# City of Sandy

### City Council Meeting

Meeting Date: Monday, April 18, 2022

- 8.1. **PUBLIC HEARING (continued)** 17 - 1111  
Deer Meadows Subdivision Appeal  
[Deer Meadows Subdivision Appeal \(April 18 hearing\) - Pdf](#)  
[Staff Presentation Slides](#)

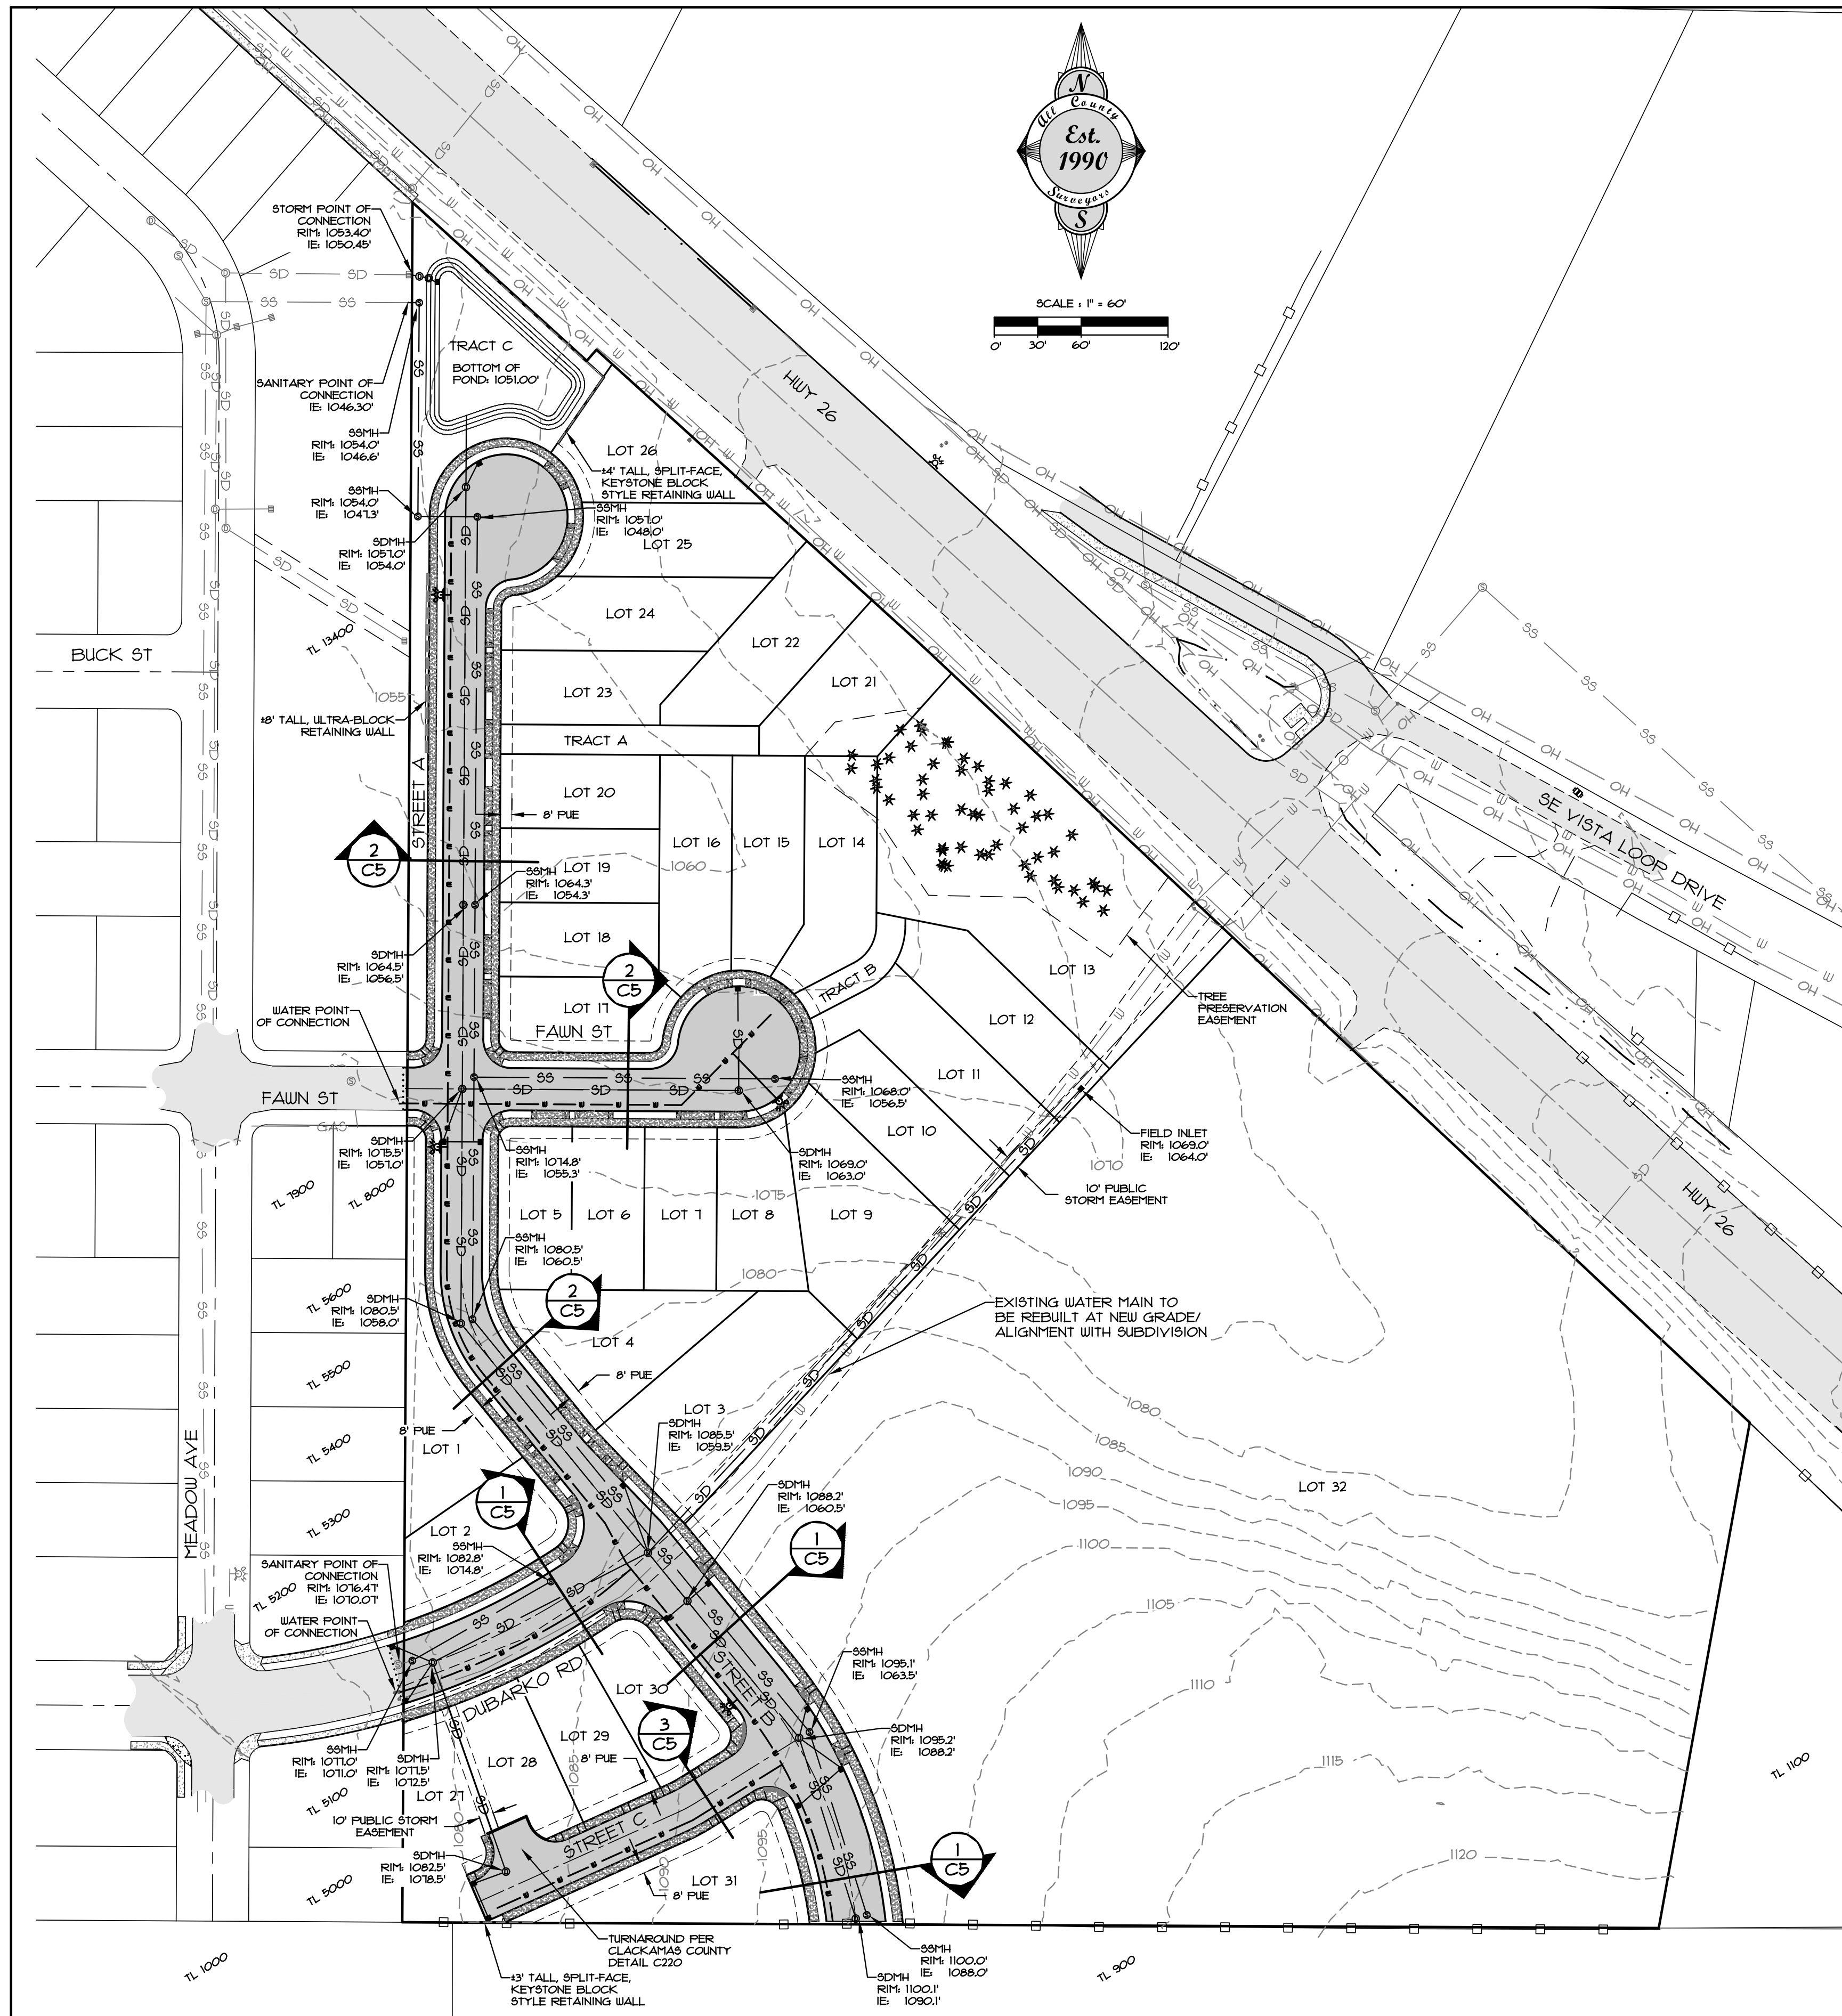
Sheet C5 of the applicant's submission contains a statement indicating that "Both of the proposed cul-de-sacs have less than 50% of their circumference covered by driveway drops". No dimensional information is shown on the site plan to support this statement. The location, number and width of all driveway approaches in cul-de-sacs shall not exceed the dimensional standards in section 17.98.100 SMC.

RESPONSE: **Exhibit 2**, attached hereto, provides driveway width information for the Fawn Street and Street A cul-de-sacs. This exhibit demonstrates that the sum of the driveway widths for each cul-de-sac is less than 50%. SDC 17.98.100.F is satisfied.
